Communities Against the Tunnels

Joint Submission to the North South Bypass Tunnel Environmental Impact Statement

April 2005

Figure 1. Variation of particle emission rate with applied power.

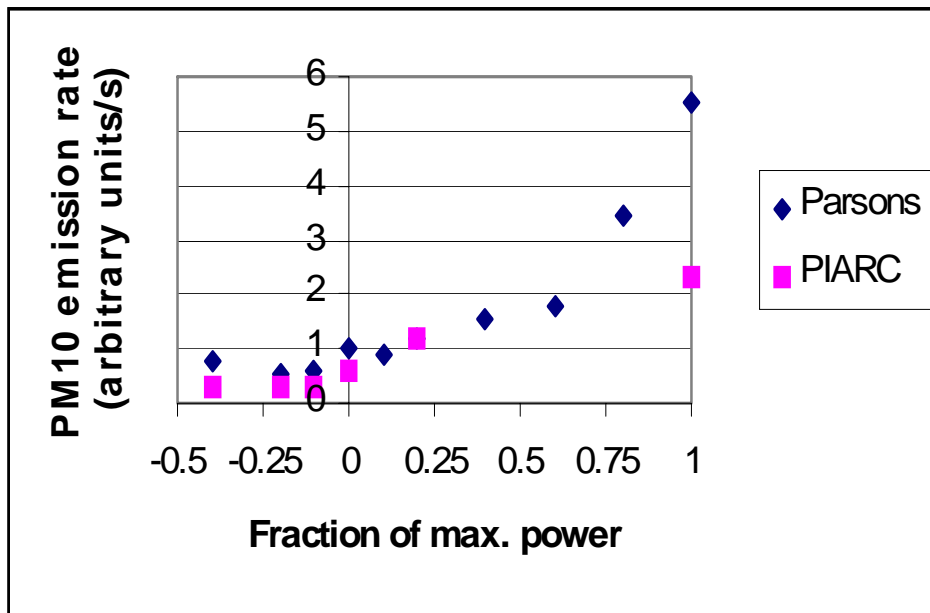
PIARC emission rates for zero grade and 60 kph agree reasonable well with the Parsons data. Calculations suggest that at 60 kph, a HGV operates at about 20% of maximum power, but on a 6% grade

it is at full power. The PIARC data have been overlaid on the attached figure by putting the PIARC emission rate for zero grade and 60 kph equal to the Parsons results at 0.2P and the estimate for 6% grade at P=1. The PIARC estimates are effectively linear with power. The difference between the two sets of data will depend on how the PIARC data overlay the Australian results and the degree of non-linearity in the emissions as a function of engine power - this awaits further study.

In our view, it is quite possible that actual PM₁₀ emissions could be a factor of two or more higher than the PIARC estimates at full engine load as the majority of the emission will in fact, come from high power operation. It should be re-emphasised that this is new knowledge, not available to Hyder, but in view of the possible potential for exceedence this aspect needs to be taken into consideration.

Figure 2. Effect of heat transfer within a road tunnel. Vent flow = 800 m³/s,

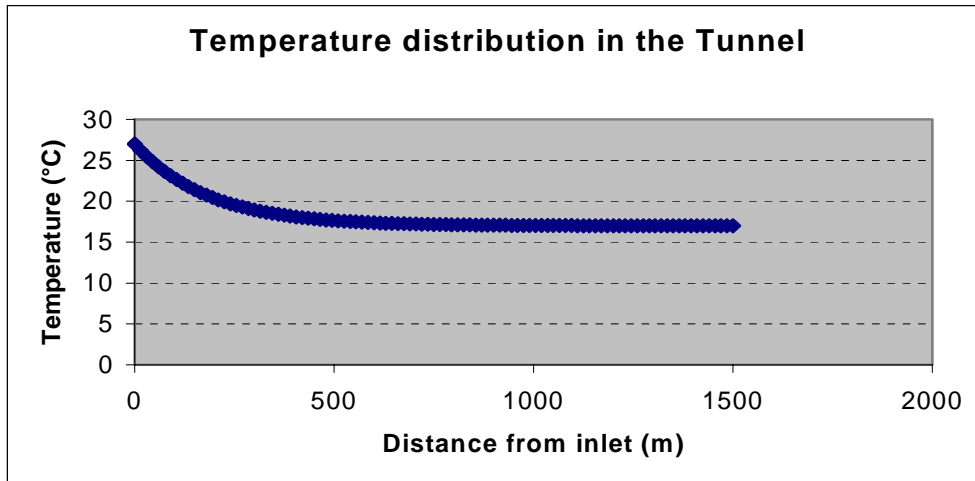
This buoyancy could enhance the effective stack height by 20 m or more. Whilst the reverse will be the case for summer afternoons, the higher dispersion rates, characteristic of neutral to unstable conditions at these times, means that the impact of negative buoyancy will be much less and also closer to the predictions of plume behaviour presented in the Hyder Reports.

As the degree of thermal buoyancy is proportional to the volume flow rate for a given temperature difference, it becomes quite small at the lowest fan speeds projected for minimum traffic flow so that there may well be only a small benefit for overnight plume strike conditions throughout the year.

Figure 3. Nitrogen dioxide monitoring data for 1998 provided by EPA NSW.

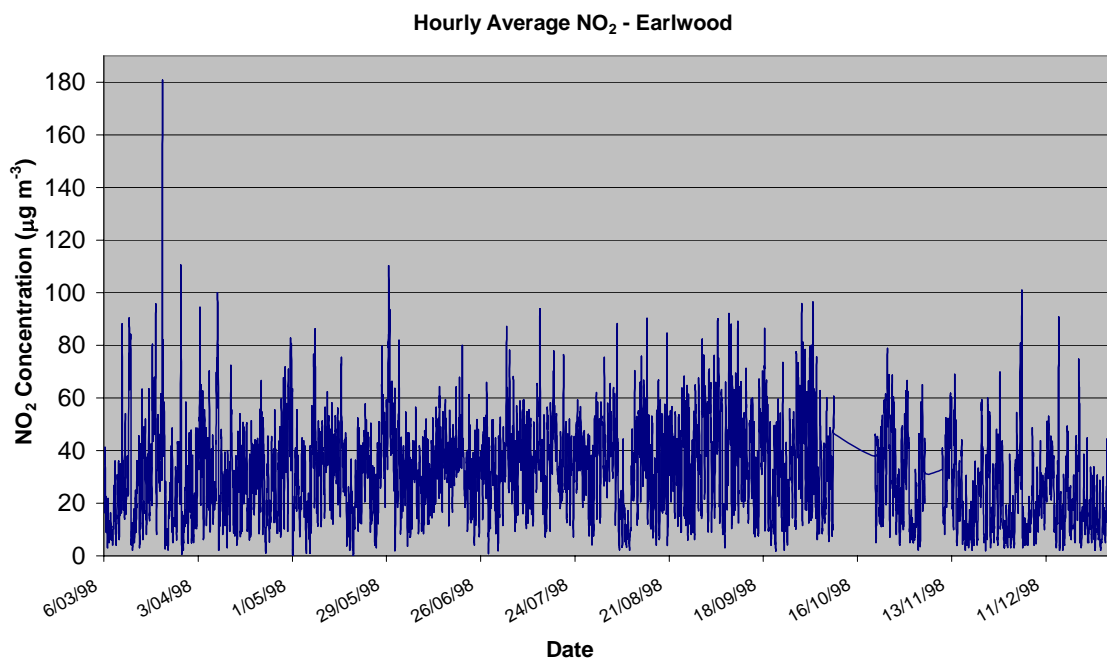
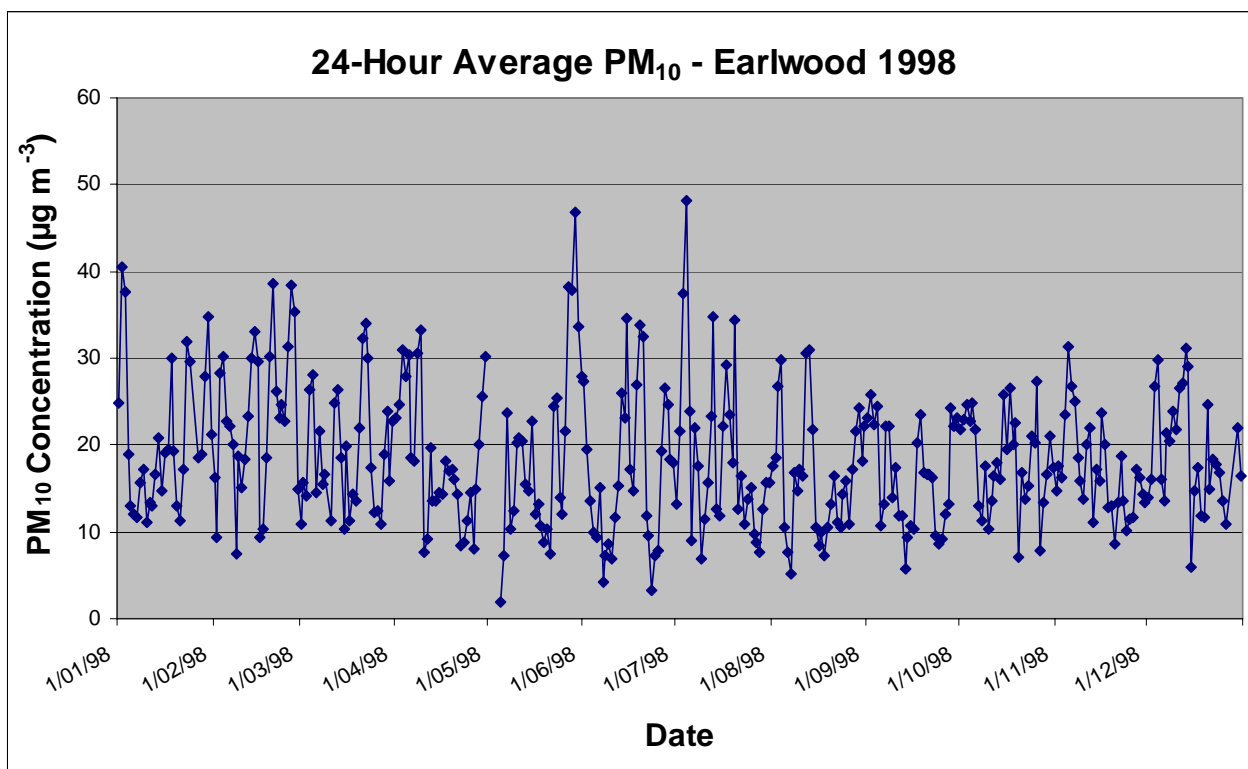
Background air pollution conditions were for the same year (1995) and location (Earlwood Monitoring Station) as the meteorology. We regard the use of background pollution data from the Earlwood Monitoring Station as appropriate in the circumstances but we also note that there could well be large local differences due to the regional terrain trapping local pollutants such as domestic wood smoke. The Hyder Reports note that data from some other years were influenced by broad-scale fires. However the Reports do not comment on the change in variation in the PM₁₀ record halfway through the year as presented in Figure 5.2 of the Reports. Our inquiries of EPA NSW resulted in them noting that during 1995 the Earlwood TEOM was tested with various measuring heads, and other changes were made to try to reduce the sensitivity to vibration that TEOMs of that vintage were particularly subject to. EPA has provided us with data from 1998 as measured at Earlwood and these for 1-hour average NO₂ and 24-hour average PM₁₀ are presented here in Figures 3 and 4.

We note that the 1998 NO₂ data indicate fewer values above 100 µg m⁻³ than in 1995 although the peak value of 180 µg m⁻³ is substantially higher than the peak of 136 µg m⁻³ in 1995. The overall average levels are similar to 1995. For the 1998 PM₁₀ data, it is clear that there is a much greater uniformity of fluctuations throughout the year than as reported for 1995. There are fewer excursions to higher values and these occur at about the same time (winter) as for 1995, but the overall average levels are about the same as for 1995.

Figure 5. Topography of the region around the stack.

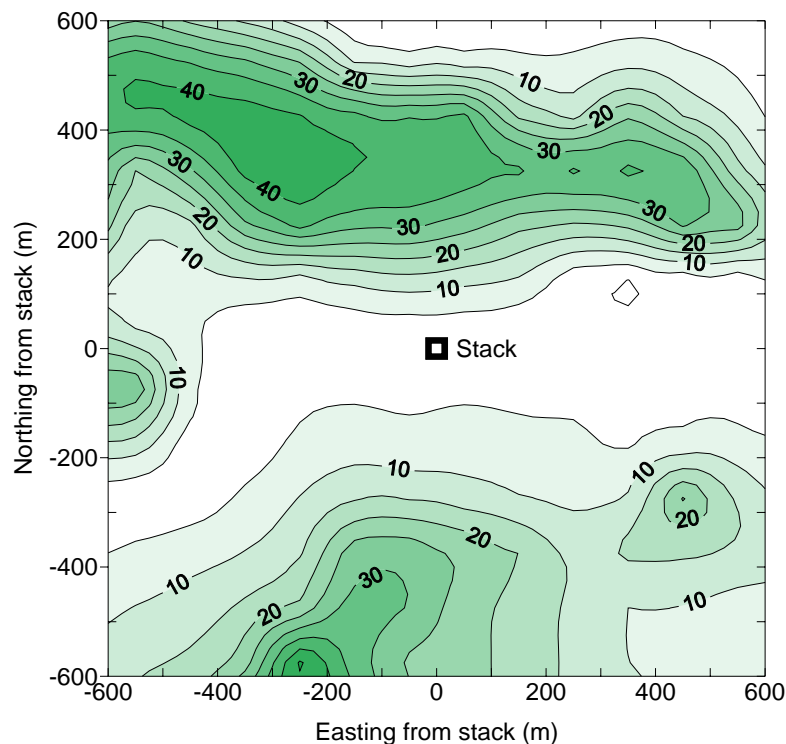
NO₂ maximum stack concentrations are dominated by values during hours 21, 22 and 23, on nearby elevated terrain of height up to 45 m above the stack base (see Figure 5), under light wind conditions (1–3 m s⁻¹), and for stable atmospheric conditions (Pasquill-Gifford stability category E–G).

Figure 6 Contour map of the maximum dispersion ratios based on measurements (at the sites indicated by dots) in the physical modelling of neutral flow conditions for the 35 m stack.

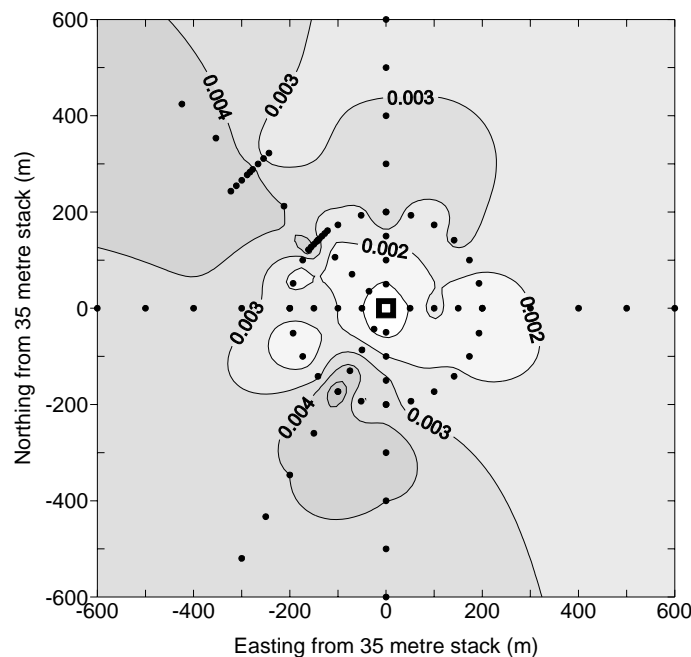
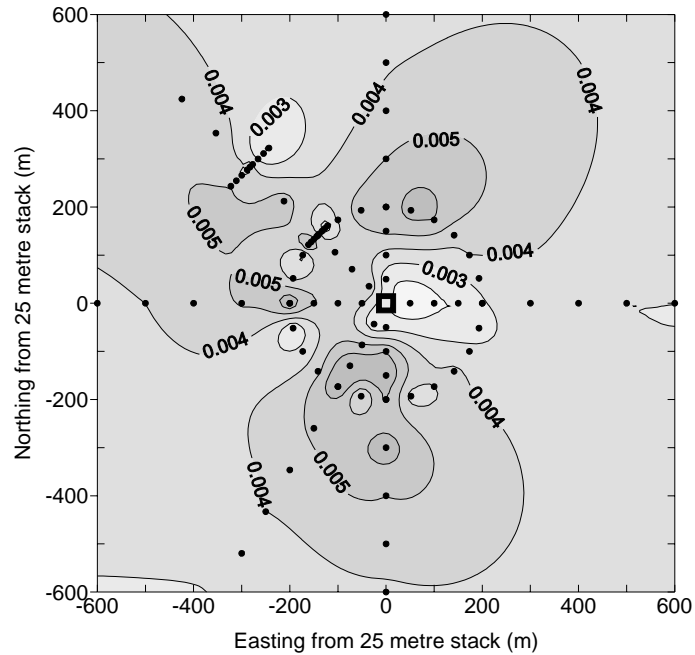
The overall quality of the presentation of the physical modelling results in the Hyder Reports is poor. There are over 200 pages of Figures in each Report showing results from each of the individual tests, but almost no summary plots other than Figure 8. In order to interpret the physical modelling results, contour plots of maximum dispersion ratios (Figures 6 and 7) have been extracted to determine the internal consistency and the influence of the topography. At each location, the maximum dispersion ratio has been extracted from the Figures in the Reports. Note that the contouring has been done to assist in visualising the results and no significance should be given to contour lines in regions where there are no data.

Both contour plots (Figures 6 and 7) show good internal consistency between the data measured in the various series for each stack, although the data for the 25 m stack appear to be slightly noisier. In both cases, the maximum dispersion ratios are observed 200–300 m downwind from the stack, possibly slightly further downwind for the higher stack. The peaks tend to occur on the hills to the north and south, as indicated by the topographic contours shown in Figure 5.

Figure 8. Comparison of maximum dispersion ratios for neutral and stable flow conditions as measured in the physical modelling for a southerly wind.

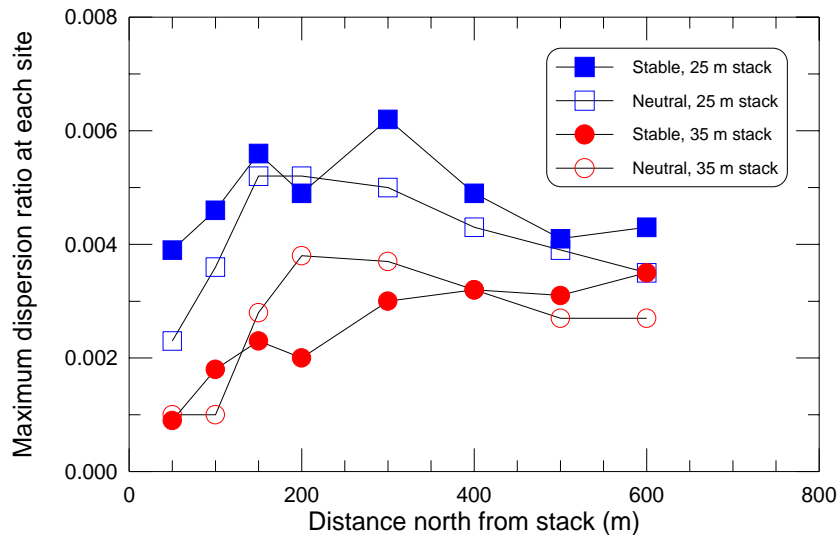
For the wind speeds and stack efflux velocities producing the highest dispersion ratios, the physical modelling showed remarkably little change in the maximum dispersion ratios at ground level when the flow conditions were changed from neutral to stable, as shown by our analysis presented in Figure 8. This is all the more surprising because the stability of 0.077 K m^{-1} used in the physical modelling is twice as large as that assumed in the corresponding mathematical modelling. This lack of influence of stability was not commented on in the report, although it has been explained in later communication with Hyder as being due to high low-level turbulence in the high wind speed conditions. It should be noted that at lower wind speeds and higher efflux velocities, the modelling results do show significantly lower glcs in stable conditions.

Some doubt about the reliability of the wind tunnel measurements in stable conditions is indicated by our analysis presented in Figure 9, which compares the vertical profiles measured 400 m downwind from the stack in neutral and stable conditions at the same efflux velocity and wind speed. Although the plume is not mixed to the ground as effectively in stable conditions, the figure shows that more of the plume is transported to higher levels in the stable case than in the neutral case. For the stack height of 35 m, the plume released into the stable environment is distributed more evenly between elevations of 25 m and 125 m, and the concentration at 125 m is more than five times greater than in the neutral case. This is counter to our expectation that stable conditions should inhibit vertical transport of the plume.

Figure 9. Comparison of vertical concentration profiles for neutral and stable flow conditions at sites 400 m downwind from the stack. The neutral profile was measured NW from the stack, and the stable profile due north of the stack.

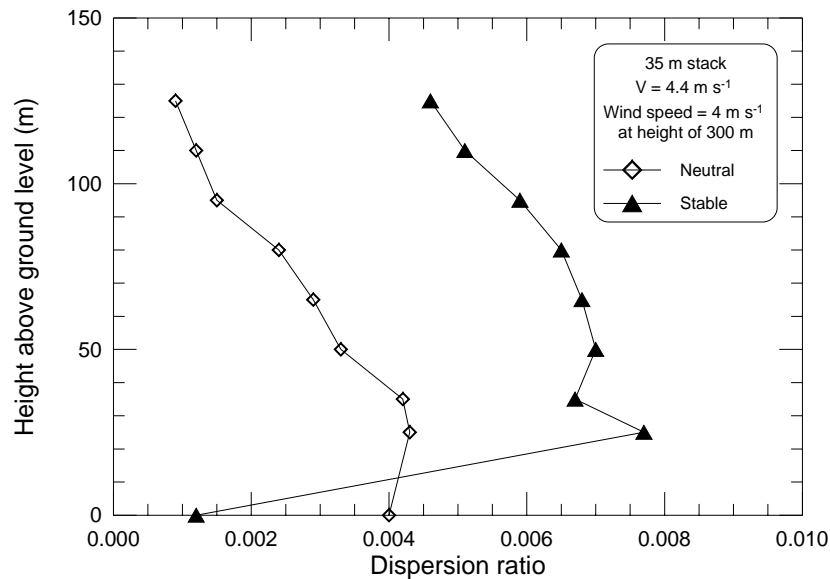
Moreover, a simple pollutant flux estimate using the concentration profiles in Figure 9 and assuming a power law velocity profile shows more than twice as much pollutant flux in the stable case as in the neutral case. The shapes of the upper parts of the concentration profiles also suggest that this difference would be greater if measurements had been made to higher elevations. If both profiles are on the plume centreline, there would need to be considerably more horizontal dispersion in the neutral case (against expectations) in order to match the pollutant fluxes in the two cases. This surprising result suggests a lack of consistency between the emissions for the two cases.

We conclude that the physical modelling for neutral flow conditions is close to reality for the modelled conditions. However, the lack of data for wind speeds below 4 m s^{-1} (equivalent to 2.7 m s^{-1} at 10 m above ground level) is a significant limitation of the physical modelling. In particular, it makes it impossible to compare the physical modelling with the mathematical modelling at the wind speeds as low as 1 m s^{-1} , which existed at the times of the highest glcs predicted by the mathematical modelling.

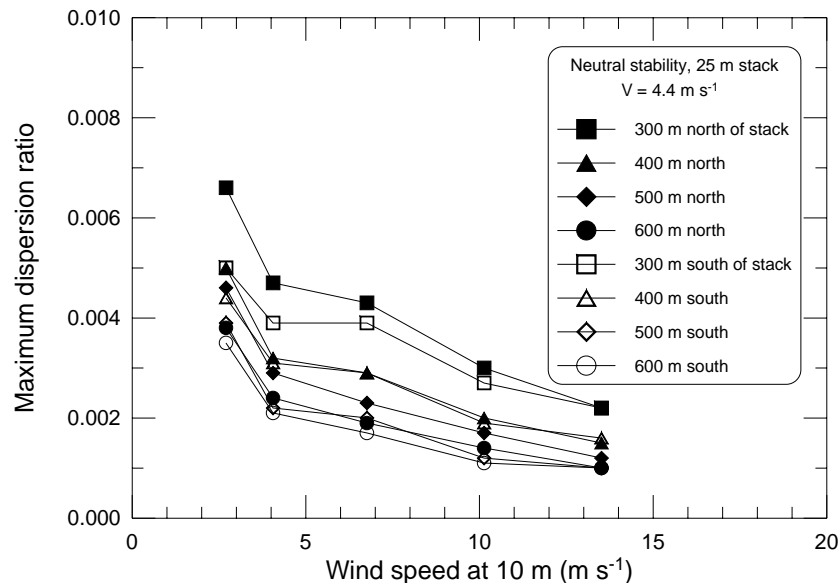
We conclude that with the data provided in the Hyder Reports it is impossible to make a valid comparison between the physical and mathematical modelling. This is in part because of the absence of physical modelling at wind speeds below 2.7 m s^{-1} for neutral conditions, and also because of the problems with the physical modelling of stable conditions. However, if the wind speeds, directions and stability classes corresponding to the maximum dispersion ratios for each efflux velocity (Table 4.1 of Part 3 of the Hyder Reports) were available, it may be possible to make a comparison for conditions for which both physical and mathematical modelling results were obtained. At present it is not possible to appeal to the physical modelling to prove that the numerical model predictions are conservative estimates of real-world conditions with the M5 East stack operating.

most likely that higher dispersion ratios occur at lower wind speeds. (Data from the physical modelling, Figures 18, 20, 22, 24, 50, 52, 54, and 56 of the Hyder Report for 25 m stack.)

Figure 11. Contour map of the ratio of maximum dispersion ratios for the 35 m and 25 m stacks for neutral flow conditions as determined by the physical modelling.

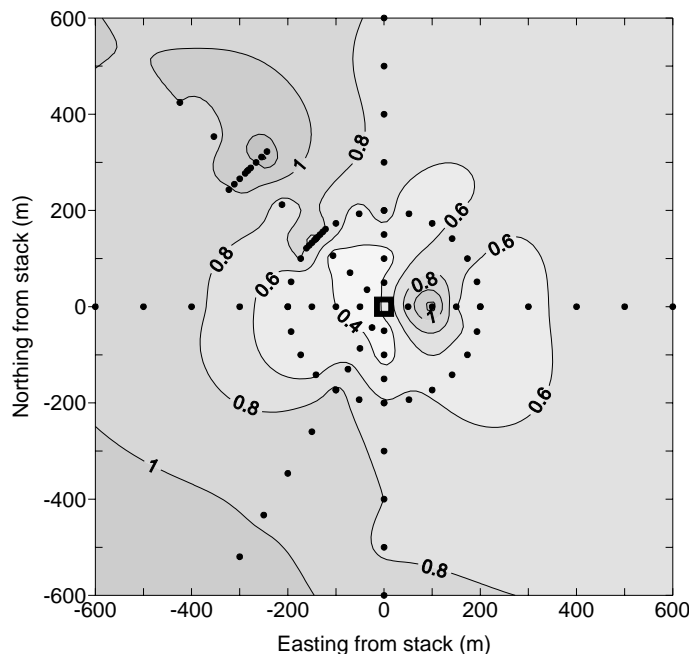
The effect of changing the stack height on the maximum dispersion ratios is shown in Figure 11 for the physical modelling. The Figure plots the ratio of results from the modelled 35 m stack to the modelled 25 m stack. Increasing the stack height from 25 m to 35 m generally reduces the concentrations by about 50% within 200 m of the stack (the exception 100 m east of the stack is probably due to an unfavourable combination of errors). The locations with slightly larger dispersion ratios (400 m NW and 600 m SW of the stack) correspond to elevated regions, and probably reflect an increase in plume impact. Note that these results are for neutral stability.

We conclude that with the stack exit conditions listed in the main Hyder Reports (2000a, b), the higher stack height (35 m) would be advantageous, especially given that conservative methods of including background NO₂ (hour-by-hour addition is not necessarily conservative), would increase the total NO₂ closer towards the air quality goals.

Figure 12. Sensitivity test of final plume height to stack exit velocity for the 35 m stack.

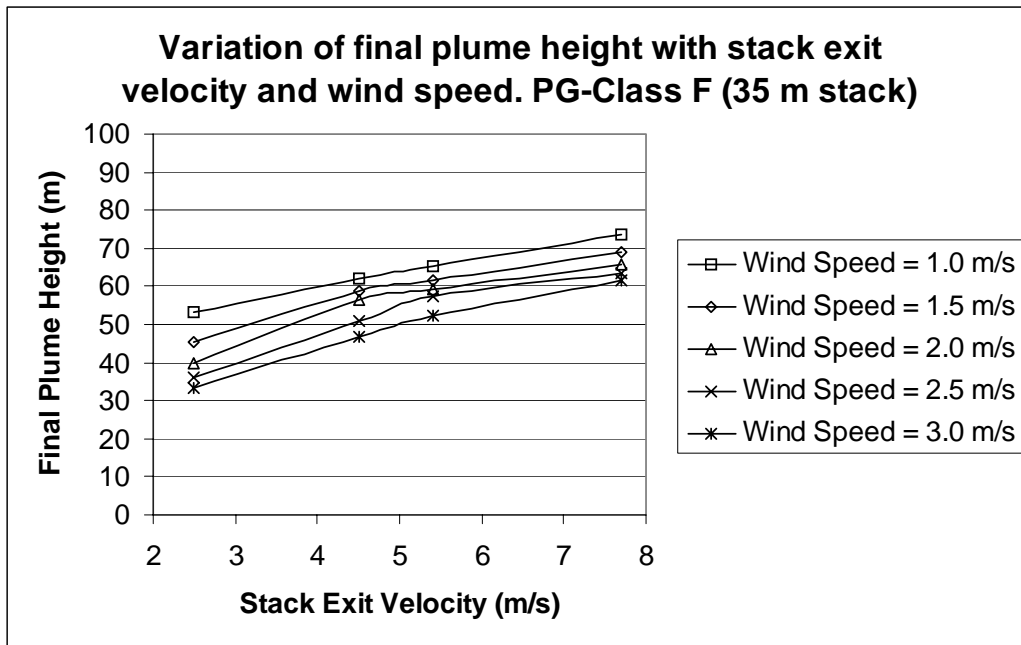
If stack exit velocity was increased for hours 21, 22 and 23 (currently 5.4, 4.5, 2.5 m s⁻¹ respectively), then ten (nine) of the top ten listed maximum stack concentrations, listed in the Hyder Report for a 25 m (35 m) stack, would decrease due to an increase in the effective plume height (see Figure 12). Note that stack-tip downwash is important when the ratio of the exit velocity to the wind speed at stack height becomes less than a ratio of 1.5, and this is predicted to be having a significant effect on maximum stack concentrations, particularly at hours 21–23.

The effect on maximum NO₂ ground level concentration of increasing stack exit velocity for hours 21 and 23 has been explored in the Hyder report (2000d) on air quality modelling for incident management. It was shown that by increasing the stack exit velocity from 5.4 m s⁻¹ to 9.0 m s⁻¹, the ground level concentration due to the 25 m stack for hour 21 on 29/10/95 was decreased from 169.1 to 111.6 µg m⁻³. When using the conservative maximum monthly background approach, this results in a cumulative concentration of 225 µg m⁻³. It was also shown that by increasing the stack exit velocity from 2.5 m s⁻¹ to 4.5 m s⁻¹, the ground level concentration due to the 25 m stack for hour 23 on 08/10/95 was decreased from 164.1 to 110.5 µg m⁻³. When using the conservative maximum monthly background approach, this results in a cumulative concentration of 224 µg m⁻³. These results illustrate that simply by increasing the stack exit velocity for certain night-time hours (e.g. hours 20-23), the air quality goals for NO₂ can be achieved, even for the 25 m stack, and when using a conservative approach to include background NO₂ concentrations.
